Submissions Report

MCROPS Midge Orchid Rd

A Submission to the Department of Planning,
Housing and Infrastructure

Project name	MidCoast Regional Organics Processing Solution
Application number	SSD-84090218
Address of the land in respect of which the development application is made	48 Midge Orchid Road, Darawank NSW 2428 (Lot 5 DP 1089990)

Figure 1: Leachate and bunding plan

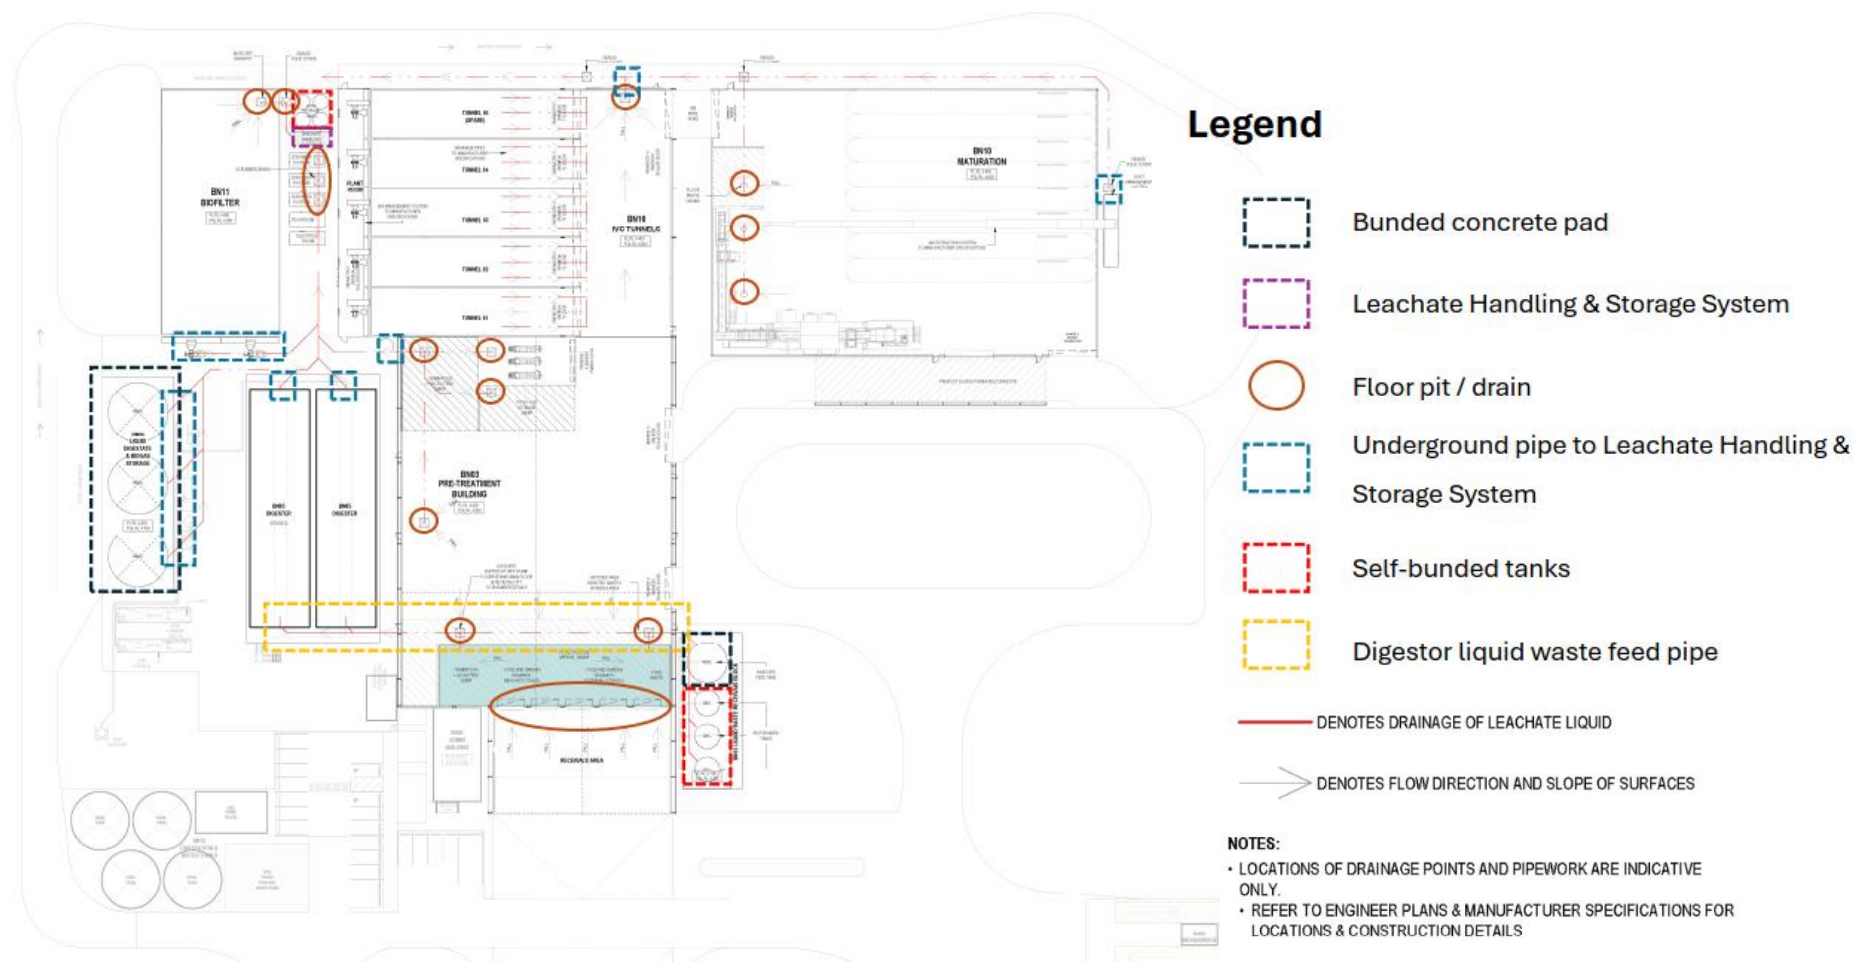
- Process liquid storage tanks shall provide sufficient working volume to buffer operational variability (including weekend/public holiday operation) and shall be configured to prevent accumulation and/or stratification of solids. Tank design shall include appropriate mixing/agitation or recirculation, access for inspection and cleaning, and isolation points for maintenance.

- Odour management systems shall be designed to ensure compliance with all planning approvals, environmental licences, and EPA guidelines, including zero off-site odour nuisance under normal operating conditions. Odour control availability shall be consistent with Contract availability requirements.

The location of these bunded systems is as follows, to be read in conjunction with Attachment 3 or Figure 1:

Figure 2: External noise sources

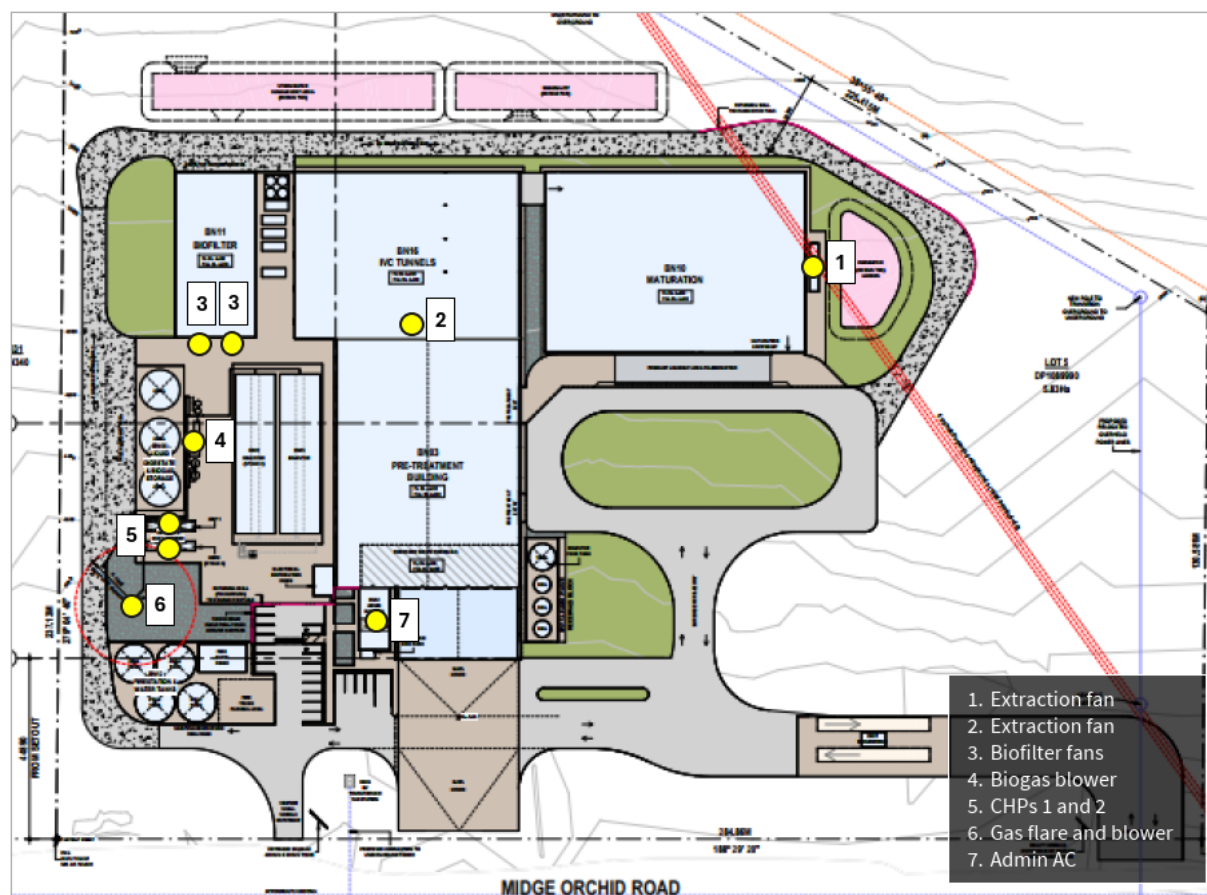
2. Identify on a site plan the location of fixed noise sources external to the process buildings, for example, fan exhausts, blower intakes, combined heat and power unit (gas turbine) intake and exhaust, and indicate how these noise sources were treated in the noise modelling.	The Acoustical Report includes a site plan as Figure 5, identifying all fixed external noise sources associated with the development, including CHP unit intake and exhaust, pre-treatment extraction fans, biofilter fans, maturation extraction fans, blower systems, and other external mechanical ventilation equipment (Figure 2 below). These sources have been incorporated into the CadnaA noise model as discrete point and area sources and positioned at their corresponding locations on the Site in accordance with the revised layout. Each source has been assigned a sound power level based on

Issue	Response
	manufacturer data and validated acoustic reference datasets. In the noise modelling, all fixed external sources were included simultaneously in the cumulative worst-case operational scenarios for day, evening, and night periods. Their combined operation was assessed together with internal building breakout and on-site mobile sources to represent the total operational noise environment. The modelling demonstrates that the inclusion of these external fixed sources does not materially increase the predicted off-site noise levels and does not change the overall assessment outcome, with compliance with the applicable noise criteria maintained at all sensitive receivers.
Other minor matters for note and correction: 3. The LAFmax, dBA sleep disturbance maximum noise trigger levels do not reflect the requirements of the Noise Policy for Industry (NPfI – EPA, 2017) and need to be correctly stated.	The sleep disturbance assessment has been reviewed and revised by Koikas Acoustics, May 2026 (Appendix M), to ensure full consistency with the Noise Policy for Industry (NPfI, 2017). In particular, the correct screening and assessment criteria have been applied for maximum noise events, including LAFmax trigger levels and associated LAeq night-time criteria. The previous presentation of sleep disturbance trigger levels has been corrected to align with NPfI requirements, including the appropriate application of RBL-based thresholds (RBL + 15 dB for LAFmax and RBL + 5 dB for LAeq, where applicable). The assessment has also been updated to ensure consistency between the adopted criteria, modelling outputs, and presented compliance tables. The revised assessment confirms that predicted maximum noise levels at all sensitive receivers remain below the corrected NPfI sleep disturbance criteria, and no exceedances are identified under the updated methodology.

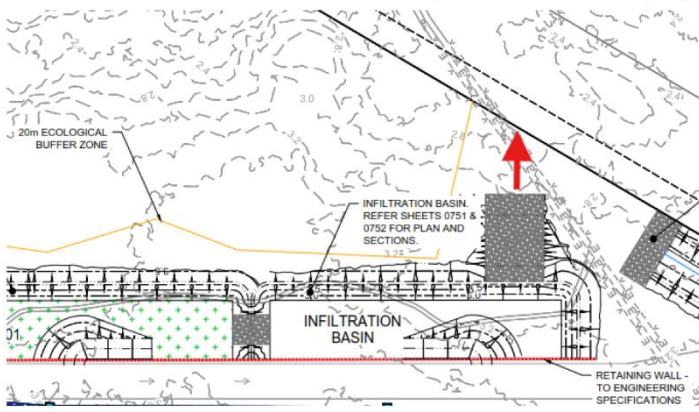
The MUSIC stormwater quality modelling adopts a combination of "forest" and "rural" land-use types to represent the pre-developed site condition. It is unclear whether the adopted parameters are supported by site-specific evidence or are aligned with the NSW MUSIC Modelling Guidelines (BMT WBM, 2015). Adopting inappropriate land-use assumptions can influence baseline pollutant loads generated by the model. Higher assumed baseline loads may	The land-use types for MUSIC modelling as detailed in Figure 7-2 of this WCMP were discussed with MidCoast Council, who advised on the designation of "forest" and "rural" land following a review of aerial imagery and site inspection.

Figure 3: Waste pit diagram

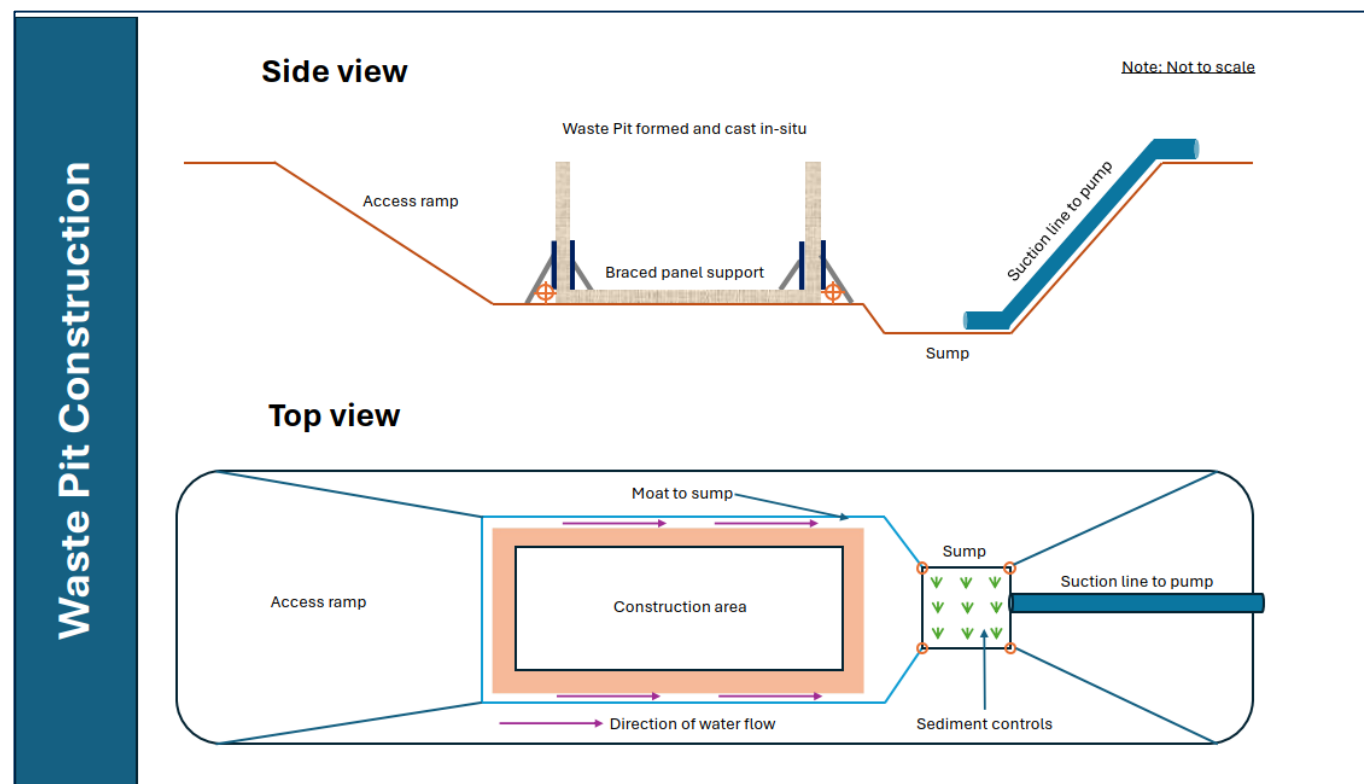
Clarify the potential for aquifer interception due to the project.	The facility design incorporates a waste receival pit which extends approx. 2 metres below ground level. This presents potential for ground water interception. The proposed waste pit will be constructed to a level below existing groundwater levels within sandy soils. The pit construction will occur inside an exclusion zone with a moat surrounding the works and battered slopes to each end allowing access for equipment. The pit will be formed and cast in-situ (Figure 3). This approach is intended to minimise groundwater ingress, while ensuring excavation stability and protection of surrounding land and infrastructure. The pit structure

Issue	Comment
make it easier for the development to demonstrate compliance with stormwater quality treatment targets, without accurately representing existing site conditions.	Correspondence from 05/10/2025 provided the map below to be designated as “forest” in blue. All other areas on the Site have been designated as “rural” land. 
MidCoast Council	
Also, the potential impacts of surface water being discharged directly into the EEC should be examined including the measures proposed to protect the EEC from stormwater impacts, e.g. greater setbacks to the EEC and replacing the spillway with a level spreader.	Figure 5-12 in the updated WCMP shows there are no adverse impacts to flooding (i.e., increases in flood levels) observed within the EEC during the 1% AEP flood event, and that neutral and even beneficial impacts have been observed within the EEC post-development. Additionally, Sheet 101 of the civil drawings indicates that the discharge point out of the Site lies outside of the EEC boundaries, with the 20 m buffer zone also being in consideration. Refer to a snippet of Sheet 101 below.
